Project Name: DDRO Motel / Hotel

Report to the Committee

Case No: 24-OVERLAY-0016
Classification: Non-Expedited
Meeting Date: June 18, 2024

Property Address: 707 York and 726, 730, 734, 736 S 7th Streets

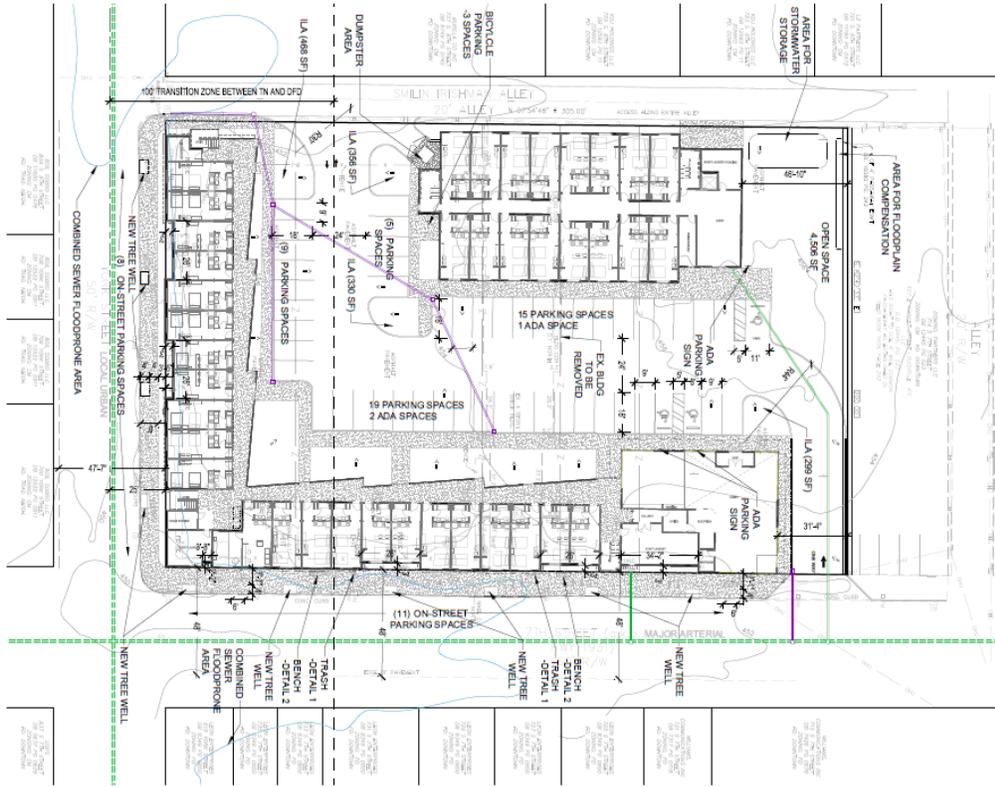
Staff recommends the open space be developed in a way to provide either public access or amenity space for the hotel/motel guests. Details like fencing, patio or walkways, public art, or additional landscaping is encouraged in this area. Staff also request information regarding the interim treatment to the area set aside for the later phase hotel building.

- 5. Details regarding the design of the open space at the northwest corner of the subject site, including but not limited to potential fencing/gates, furnishings, patios or walkways, lighting, or public art, shall be provided to staff for review and approval prior to construction.**

- 7. The applicant shall submit plans for the interim treatment of the proposed hotel footprint area to staff for review and approval. Staff recommends that this area be landscaped or otherwise pervious in nature in the interim.**

East Elevation NTS

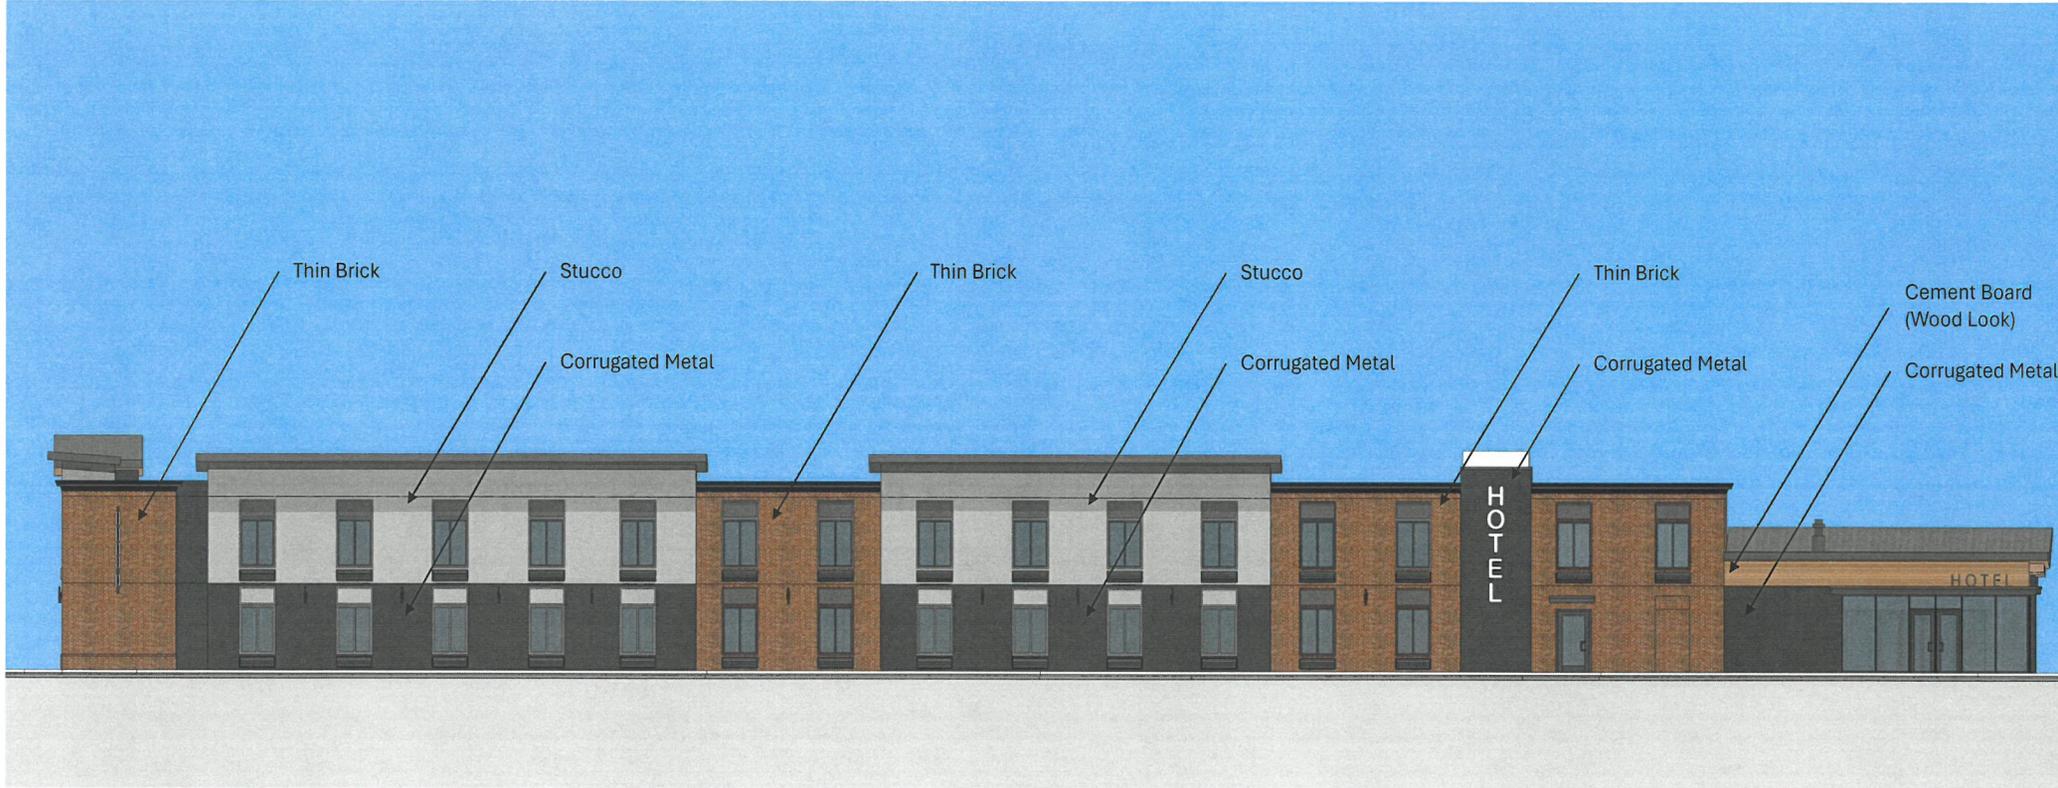
The new motel building will include 48 rooms, 24 on each floor. It is contemporary in style and has architectural details that are common of other modern motel/hotel projects. The materials of brick, horizontal metal siding, stucco, and wood look cement board are compatible with the surroundings on the southern fringe of the district. The design places some emphasis on the corners, having these portions of the building serve as focal points through height changes, unique roof shapes, public art, or wrap around storefront glass to define the main entrance. However, there is only one main entrance and one secondary entrance facing a street, both located to the north of the motel building facing S 7th. Staff highly recommends at least one more door and awning, similar in style and design to the secondary door proposed on S 7th, be added along York Street to access the southeastern stairwell. It is not required to be a public access door or unlocked at all hours, but could be an emergency exit or key card access door. The presence of a door/entry in this location would make the overall design more compatible with the guidelines.

- 1. All glass on the ground level of the S 7th and York Street facing facades shall be clear. Front glass shall not be tinted, smoked, or have added reflection or mirroring. If the glass is low-E, it shall be clear.**
- 2. The applicant shall consider the installation of a glass person door with awning on the south York Street façade accessing the southeast stairwell. If included, the applicant shall submit an updated elevation to Planning staff for review and approval.**
- 3. Rooftops shall not look cluttered from any pedestrian vantage point. All mechanical or utility equipment shall be well-integrated into the overall design.**
- 4. Exterior lighting details shall be provided to staff for review and approval prior to construction taking place.**
